Day Apparels(12483) Day Fashion(12571)

M H Tower, 21, Vogra, Gazipur – 1704
(23.981525N, 90.381451E)

8th December 2016

Observation

Apparently high punching stress in flat slab

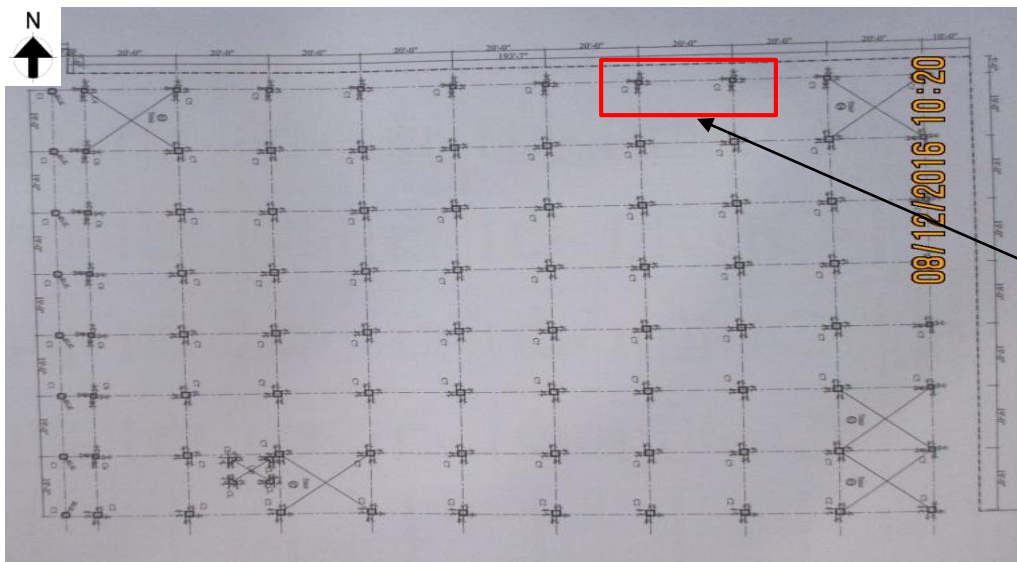
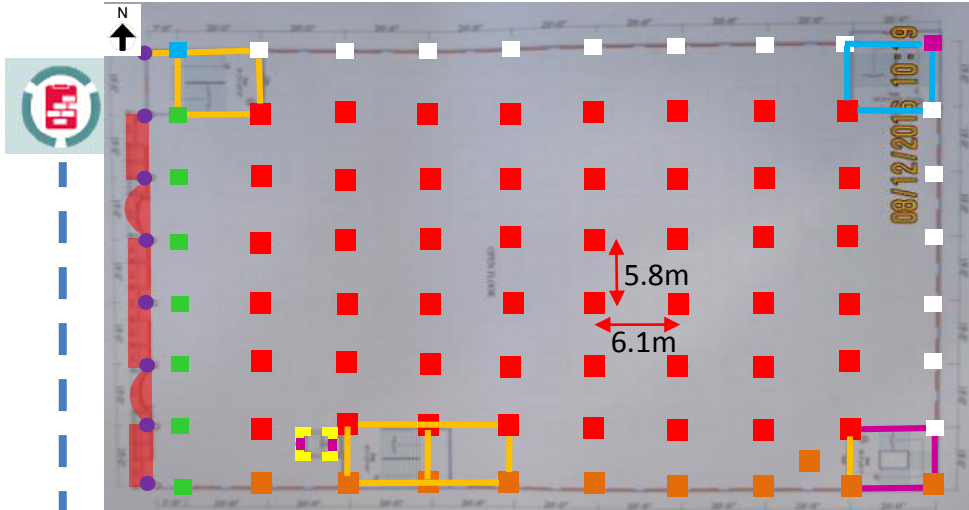
Cursory calculations shows risk of punching shear due to heavy loading on flat slab due to built up

From the cursory calculations flat slab was appeared to be stressed by punching shear due to loads from the toilet build-up and partition walls in typical floor level.

Item No.	Observation	Recommended Action Plan	Recommended Timeline
1	Apparently high punching stress in flat slab	Building engineer to conduct a engineering assessment to check the adequacy of the flat slab and foundation of the building .	6-weeks
2	Apparently high punching stress in flat slab	Verify in-situ concrete stresses by 100mm dia. cores from 4 nos areas of flat slab –not located within the column/slab punching zone.	6-weeks
3	Apparently high punching stress in flat slab	Produce and actively manage a loading plan for all floor plates within the Building, giving consideration to floor capacity and column capacity.	6-months
4	Apparently high punching stress in flat slab	Continue to implement the load management plan.	6-months
5	Apparently Lack of Lateral stability	Building Engineer to review the lateral stability of the building for the BNBC recommended lateral load as part of engineering assessment.	6-weeks

Apparently Lack of Lateral stability

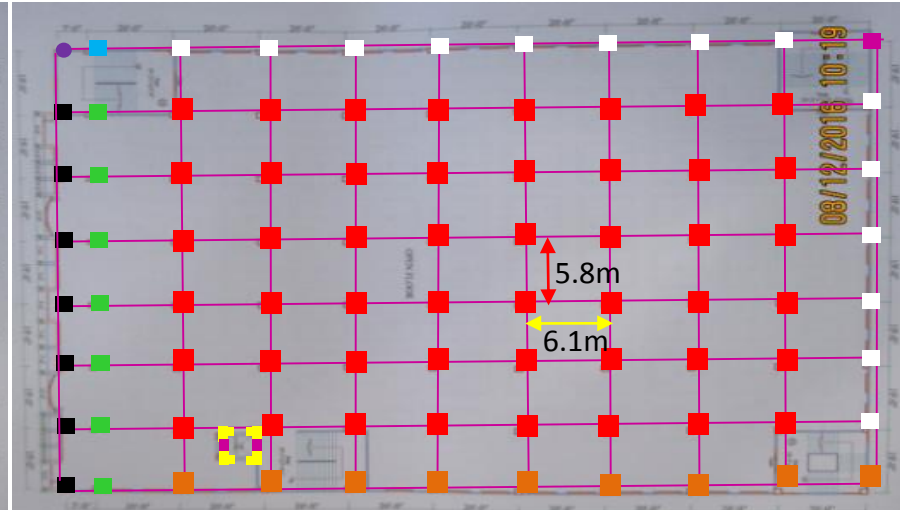
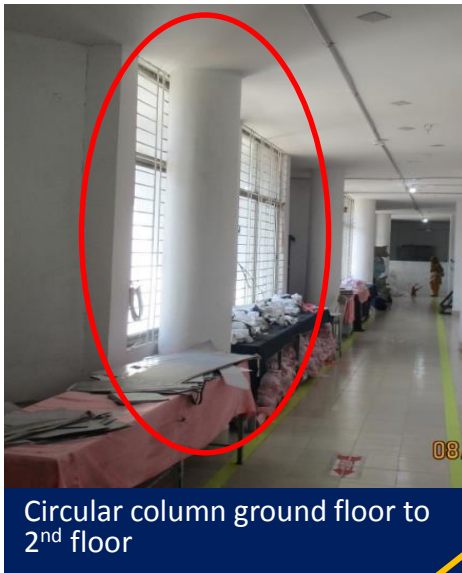
Due to combination of flat slab and beam column structural system, the lateral load path is not clear. Building engineer to check lateral stability of the building against lateral load as per BNBC load.

6	Apparently Lack of Lateral stability	Carry out remedial works resulting from engineering assessment if necessary.	6-months
7	Discrepancy found between as built condition and provided drawing	Building engineer to survey the whole building and produce as-built documentation reflecting the as constructed condition.	6-weeks

Discrepancy found between as built condition and provided drawing

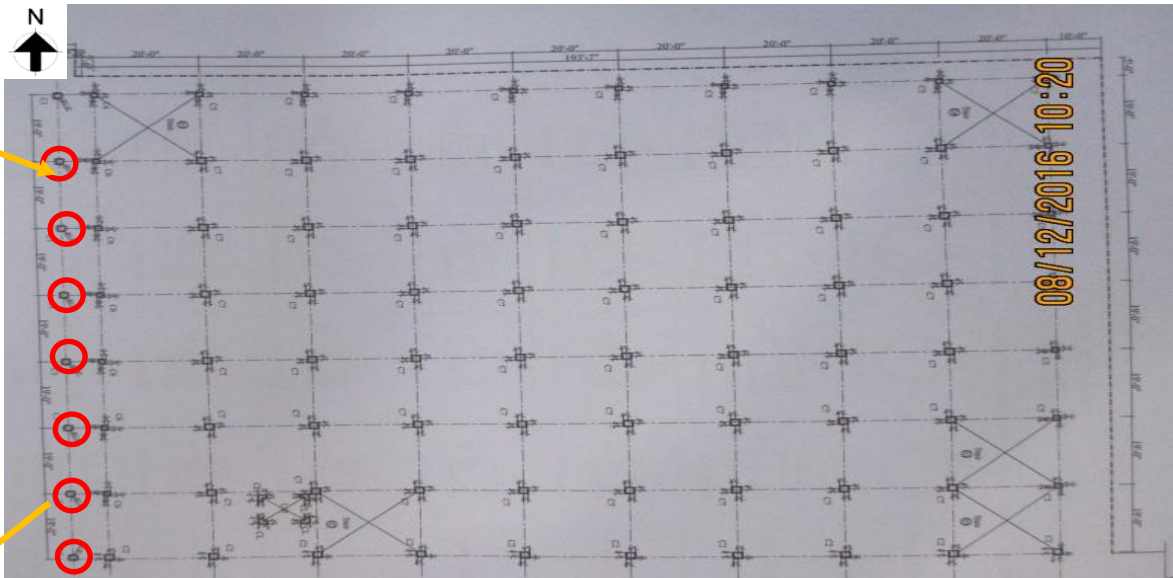
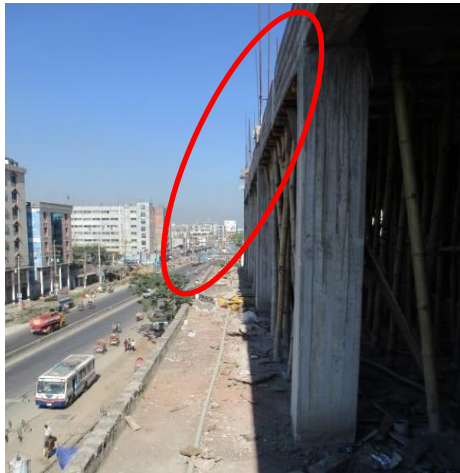
C1 type columns were found square shape on 3rd and 4th floor and circular shape from ground to 2nd floor where in column schedule, this column shape was shown as circular on all floor

Typical floor plan

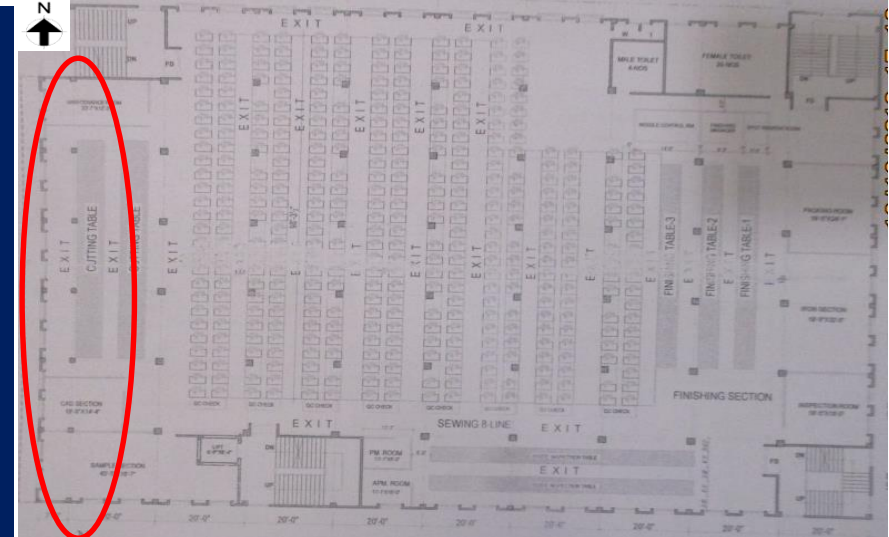
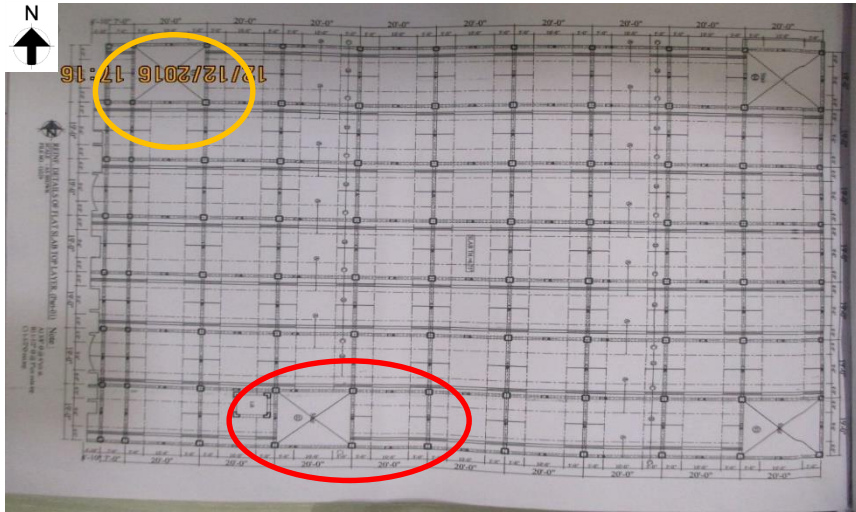
Circular shape brick wall was observed instead of straight wall in drawing

No Cantilever portion on 4th floor top Slab was observed which was present in drawing

Front elevation did not match with provided architectural drawing. Also the cantilever was absent which was shown in drawing.

Slab reinforcement with concealed beam layout for typical floor

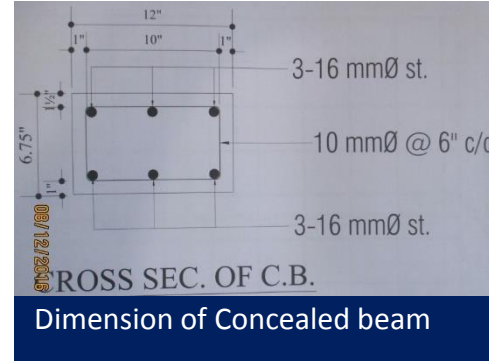
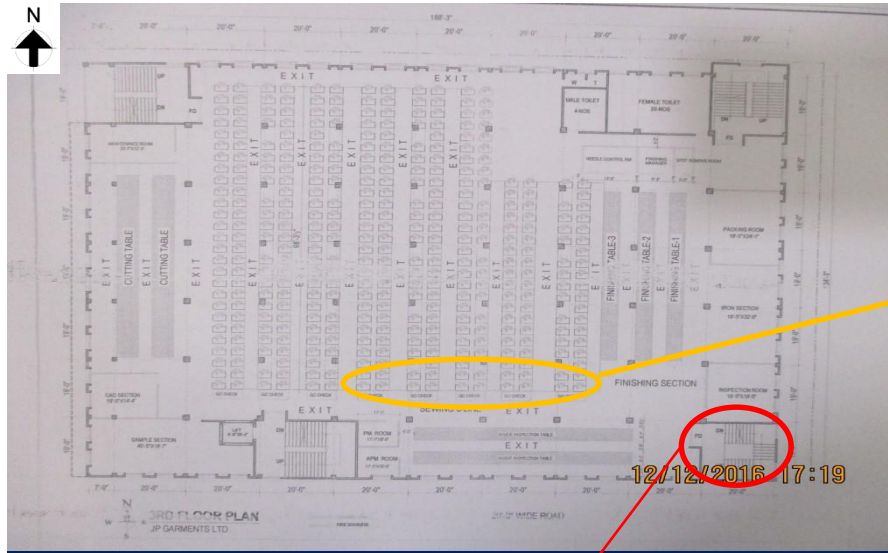
Beam was observed under 4th floor top slab and around stair case where as-build structural drawing showed concealed beam through the typical floor slab

Lack of edge protection

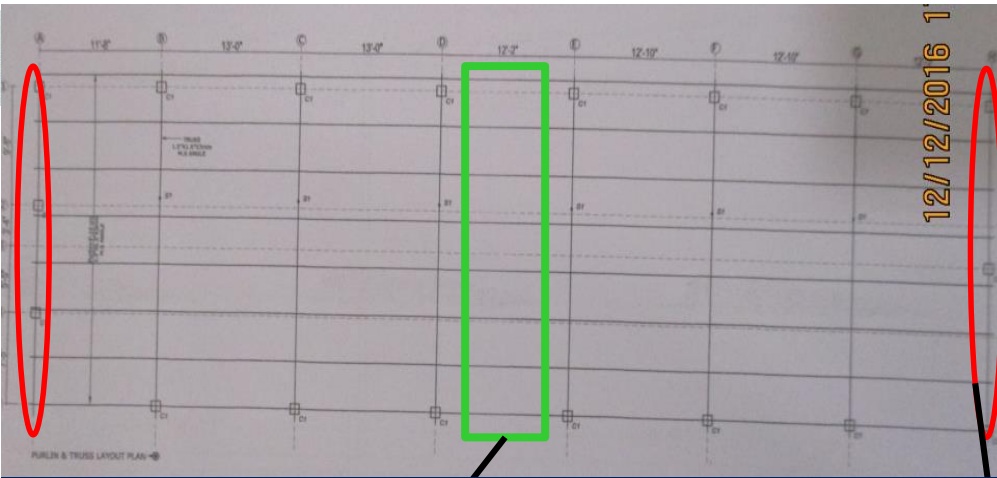
No edge protection system was found in construction area. Factory is required to provide edge protection immediately to avoid falling hazard.

Purlin and Truss Layout Plan

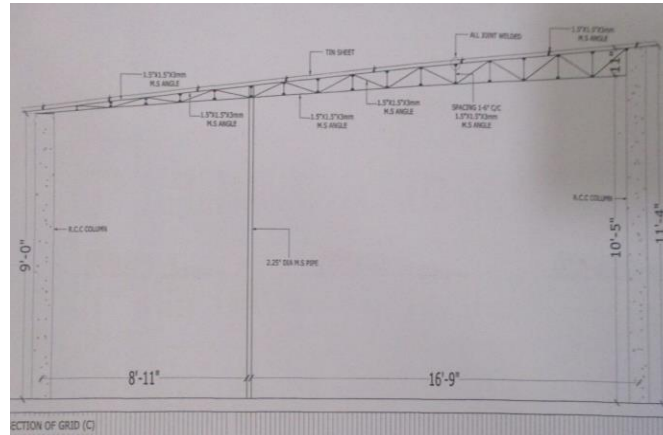
During inspection, only seven purlin were found instead of eight purlin in drawing. Also no truss was observed at the both end of the shed.
